THE CITY OF KEY WEST
3140 Flagler St,
Key West, FL 33040

ADDENDUM #1
Mallory Square Electrical Upgrades
Project: FM1301
Invitation to Bid: ITB 15-005
May 27, 2015

ADDENDUM #1
Mallory Square Electrical Upgrades
Project: FM1301
Invitation to Bid: ITB 15-005
May 27, 2015

1 Typical Trench Detail
N.T.S.

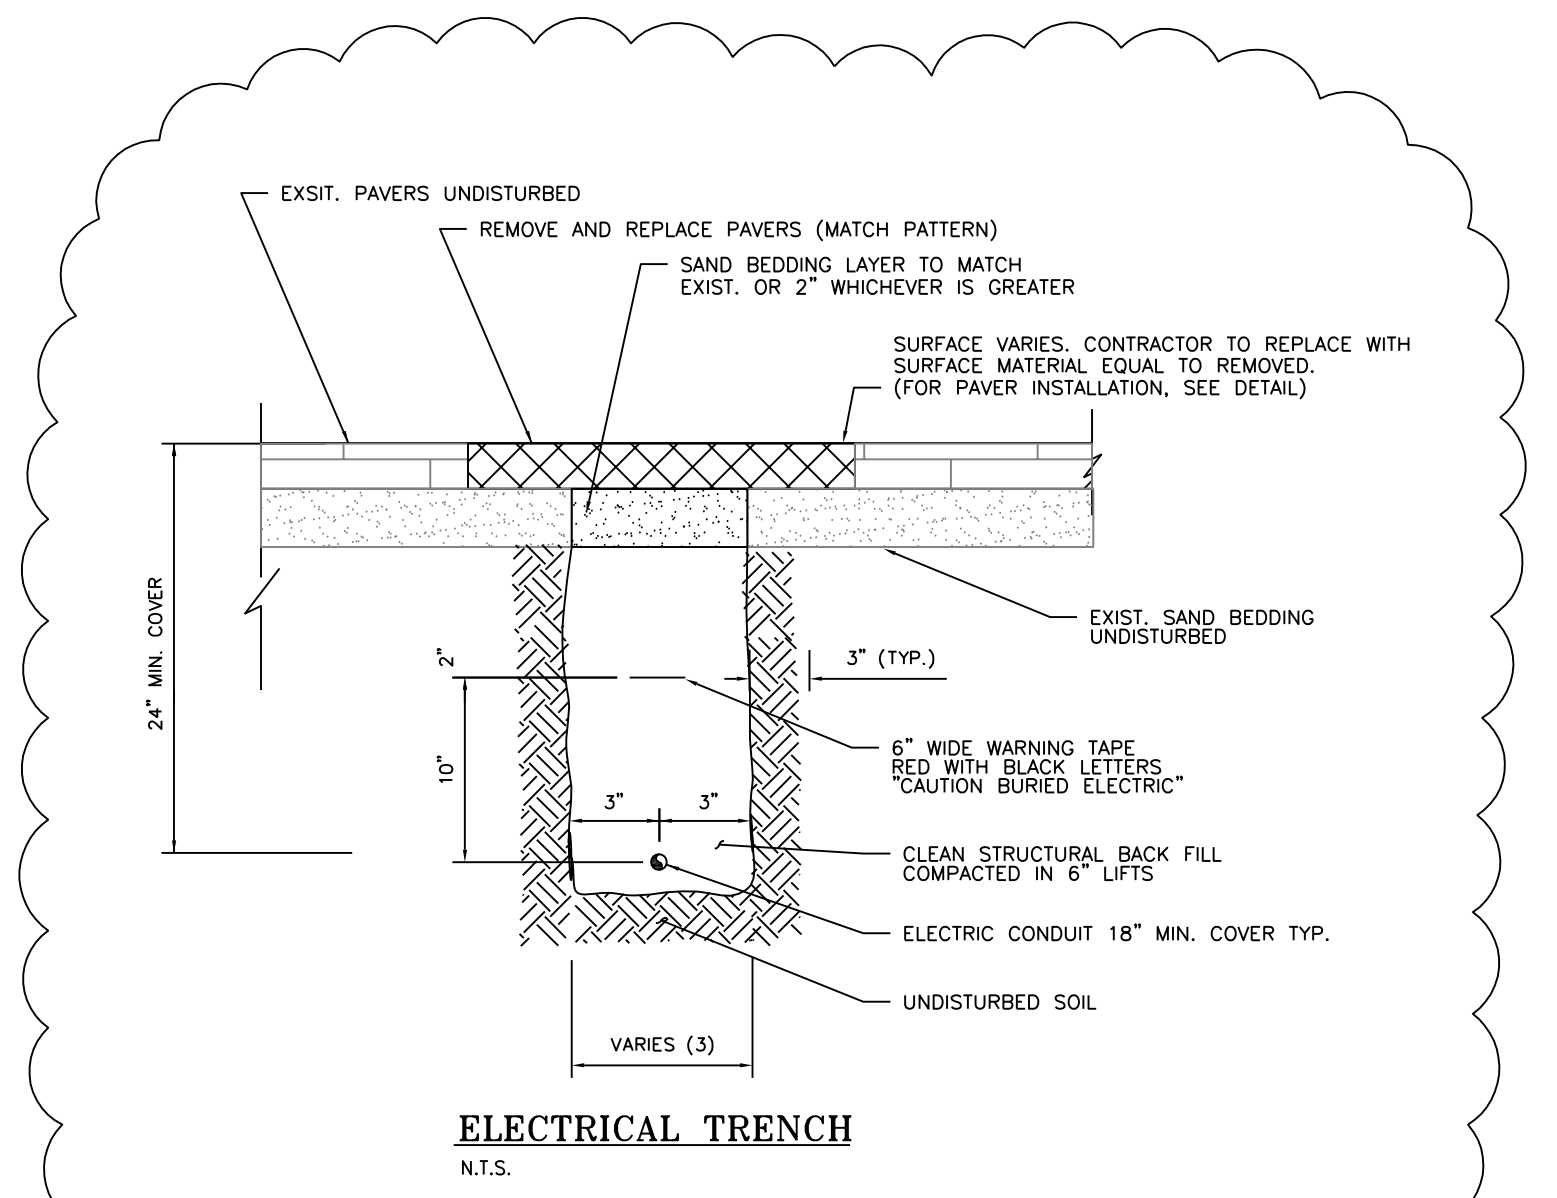
1. The attached sign-in sheet provides information on the attendees of the mandatory pre-bid meeting.
2. The attached drawing C-2 revised May 21, 2015 shall replace the Sheet C-2 in the original construction drawing set. The typical trench detail has been modified to delete flowable fill.

PEDESTAL DETAIL A - BASE BID

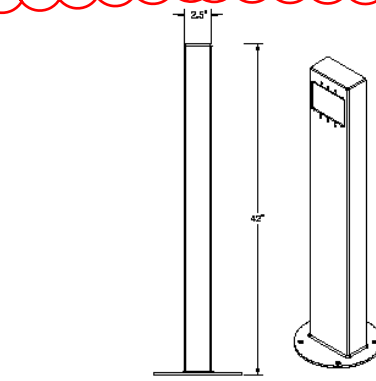
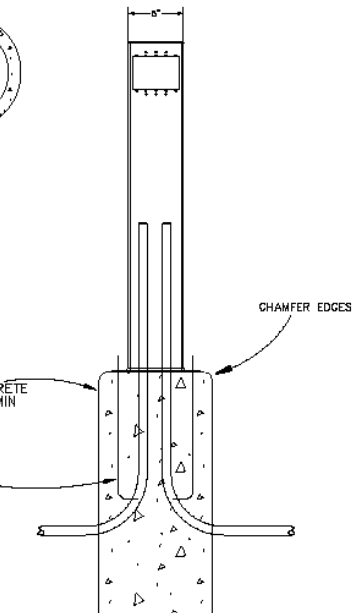
3. The attached drawing E-1 revised May 21, 2015 shall replace Sheet E-1 in the original construction drawing set. The drawing has been modified to indicate that the "PEDOC" powder-coated, stainless steel pedestal (Detail 'A') is now specified for the base bid while the precast concrete pedestals and aluminum/brick pedestals are bid alternates #1 and #2, respectively.

JOB NO. 141017
DRAWN: RQY
DESIGNED: RQY
CHECKED: RQY
QC
SHEET E-1

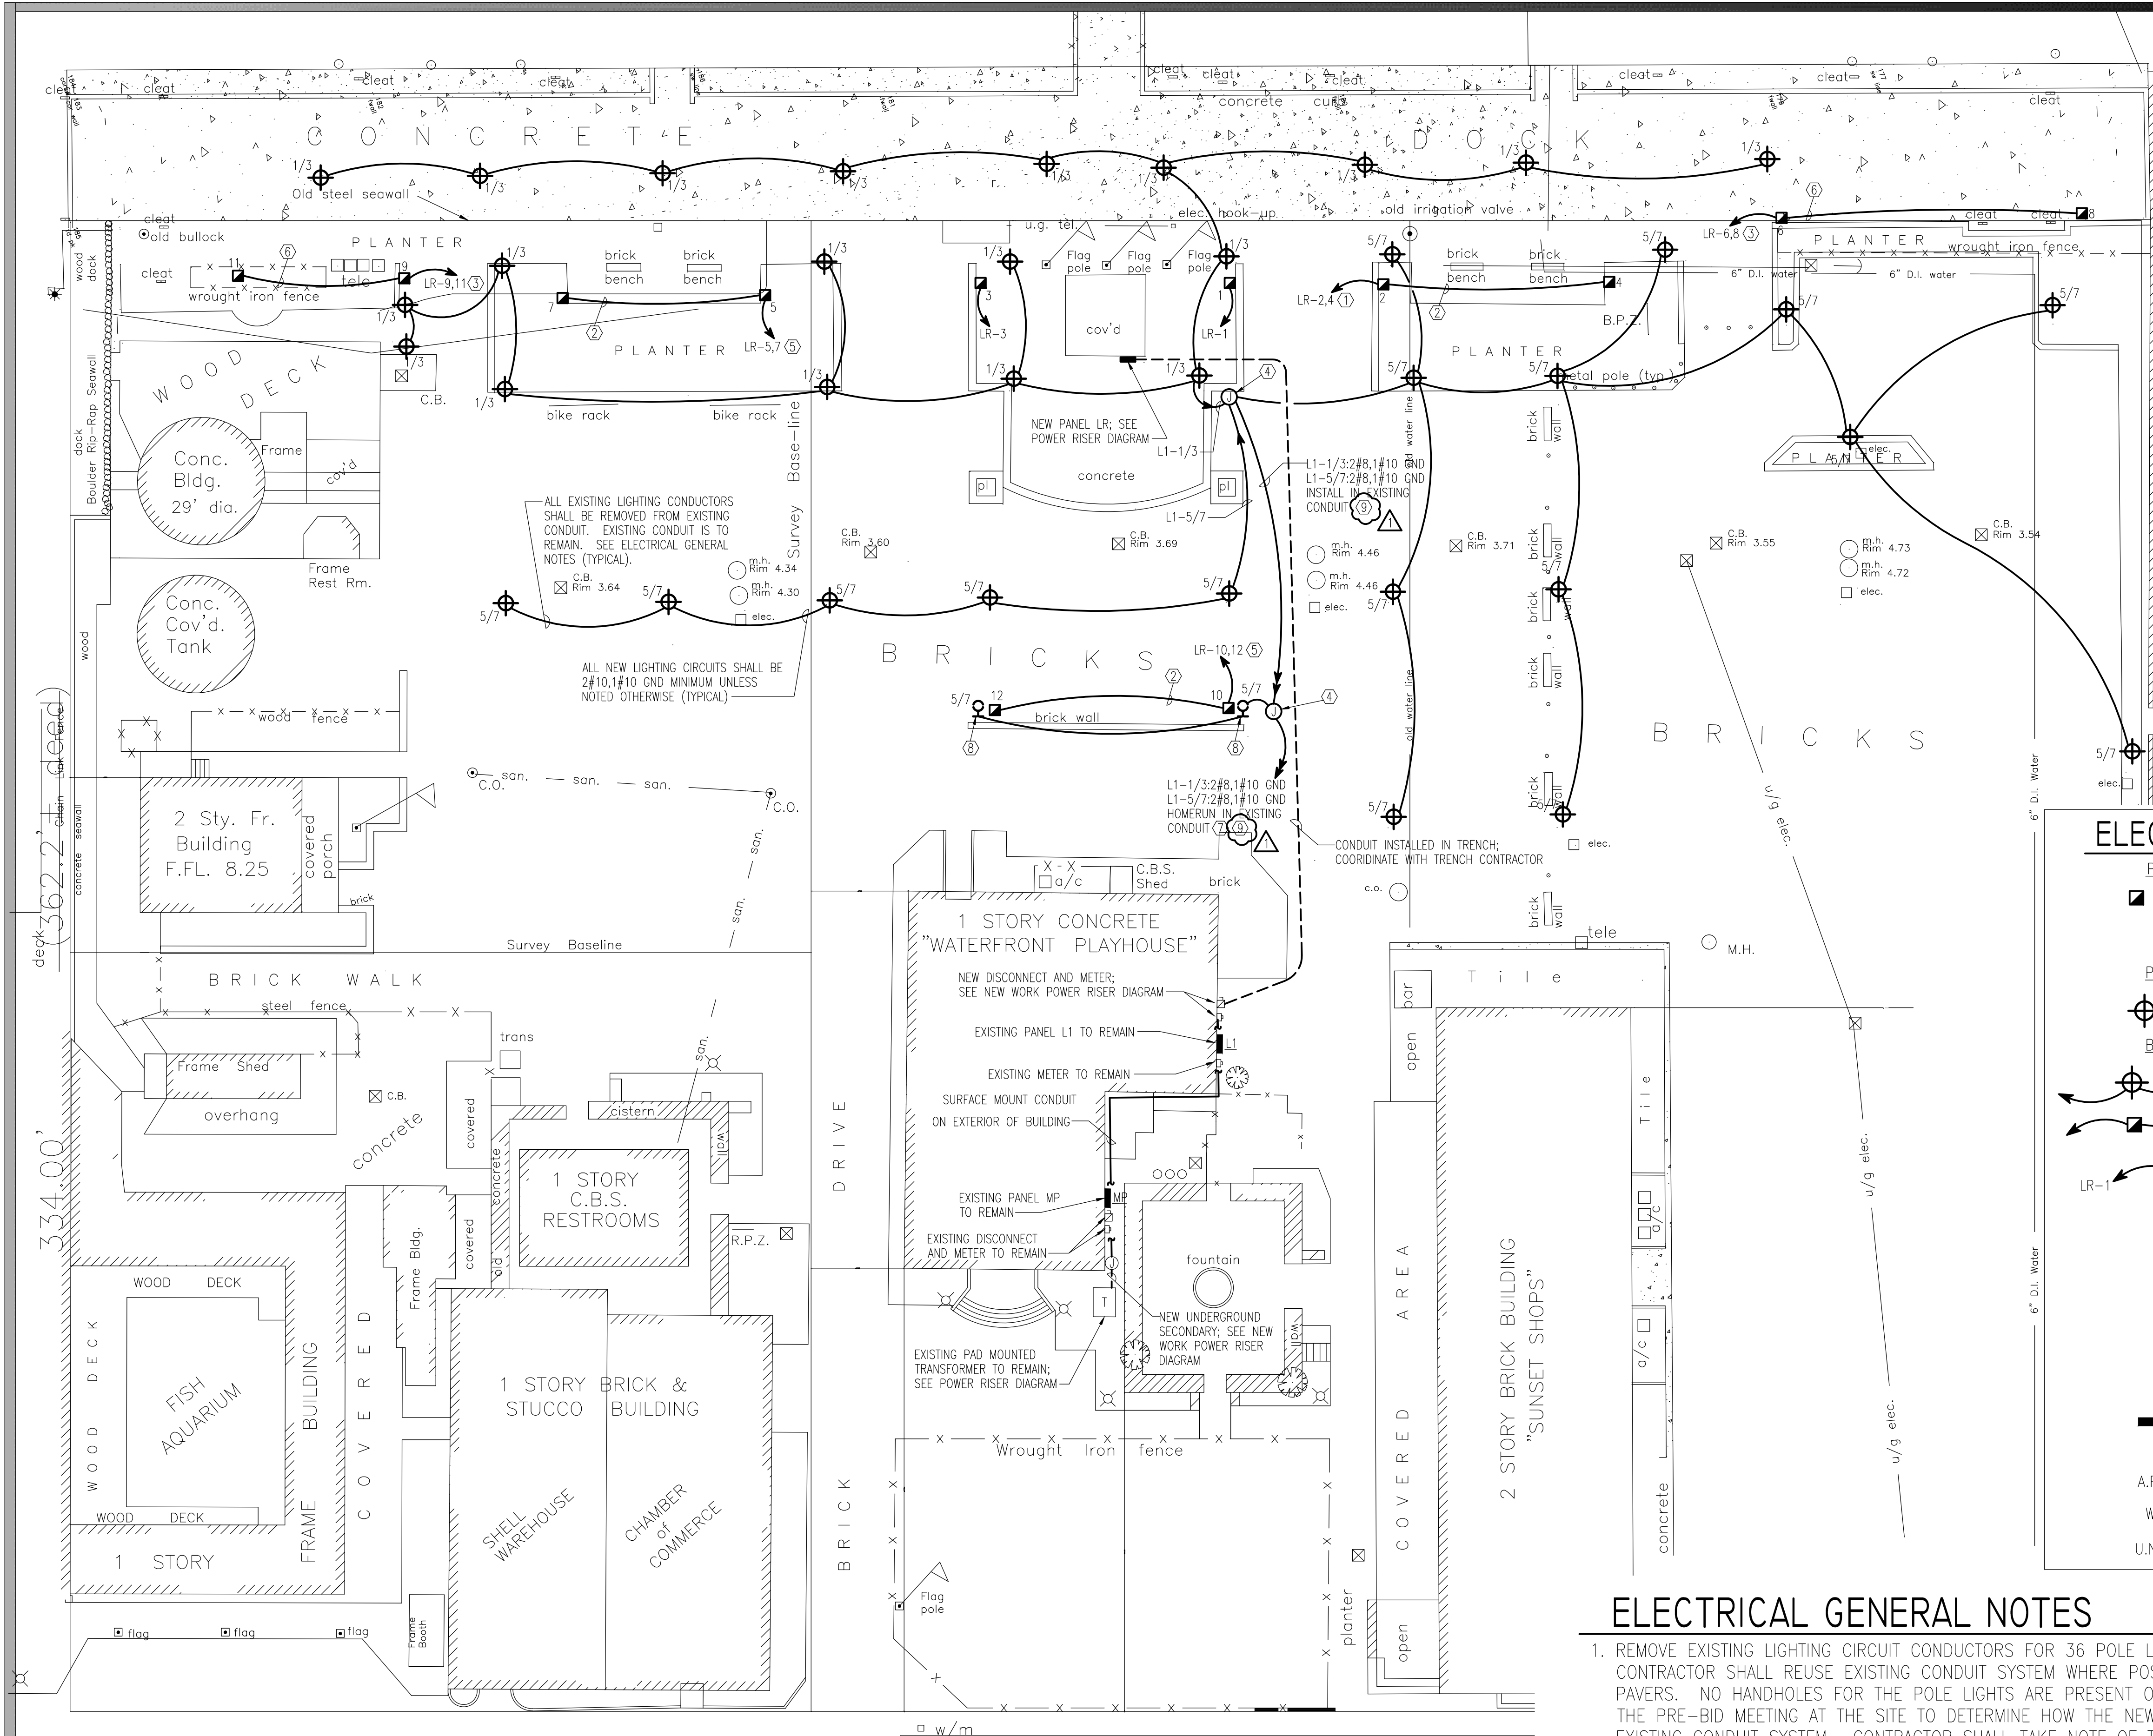
- Q Sheets E-1 and E-2. Where will rigid conduit be used?
- A No metallic conduit shall be used, above or below-ground. All proposed conduits, bends and fittings shall be SCH80 UV-resistant PVC.

- Q Sheet E-1: How will conduits be attached to the Waterfront Playhouse building?
- A Stainless steel unistrut, straps and tapcons shall be used. Conduit shall be installed in accordance with Article 352 of the NEC 2011 Edition.

JOB NO. 141017
 DRAWN RQY
 DESIGNED RQY
 CHECKED RQY
 QC
 SHEET E-2

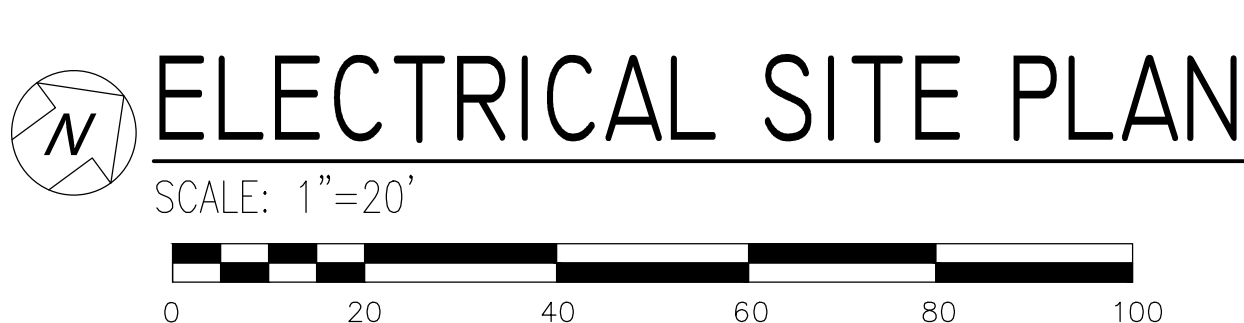
4. The attached drawing E-2 revised May 21, 2015 shall replace Sheet E-2 in the original construction drawing set. The revised drawing details replacing underground junction box 'J' with an 18" wide x 30" long x 18" deep composite box and stipulating that no below-ground splices allowed on this project.

- Q Sheet E-2. Is it an option to replace/enlarge Junction Box 'J'?
- A Yes. Note that a revised Sheet E-2 (which calls for replacement of 'J') is included in Addendum #1.

- Q Sheet E-2. Is it an option to run new conduits in the proposed trench to allow for home-runs for lighting circuits?
- A Yes. Refer to revised Sheet E-2 included in Addendum #1.

- Q Sheet E-2. Can more detailed information be provided on the proposed pedestal locations?
- A Pedestal and conduit trench locations will be field located by the Contractor in locations approximate to those shown on Sheet E-2. Locations will be subject to approval by the Owner prior to installation or excavation.

- KEY NOTES:**
- ① 3#10,1#10 GND, 3/4" C
 - ② 2#10,1#10 GND, 3/4" C
 - ③ 3#6,1#10 GND, 3/4" C
 - ④ REPLACE THE EXISTING UNDERGROUND JUNCTION BOX WITH NEW COMPOSITE PULL BOX MARKED "ELECTRICAL" EQUAL TO HIGHLINE CHA132418 WITH BROOKS/OLDCASTLE N16 BOX WITH FIBERLYTE BOLT-DOWN LID. INSTALL CONDUCTORS; DO NOT MAKE SPLICES IN THE PULL BOX.
 - ⑤ 3#8,1#10 GND, 3/4" C
 - ⑥ 2#8,1#10 GND, 3/4" C
 - ⑦ ROUTE CONDUCTORS THROUGH EXISTING LIGHTING CONTACTOR FOR CONTROLS
 - ⑧ EXISTING HID AREA LIGHT FIXTURE TO REMAIN; CONNECT TO NEW CONDUCTORS AS INDICATED. VERIFY FIXTURE VOLTAGE PRIOR TO REMOVING CONDUCTORS.
 - ⑨ NEW CONDUITS CAN BE INSTALLED IN THE SAME TRENCH FROM PANEL L1 TO NEW COMPOSITE PULL BOX (SEE KEYNOTE #4) IF NECESSARY.
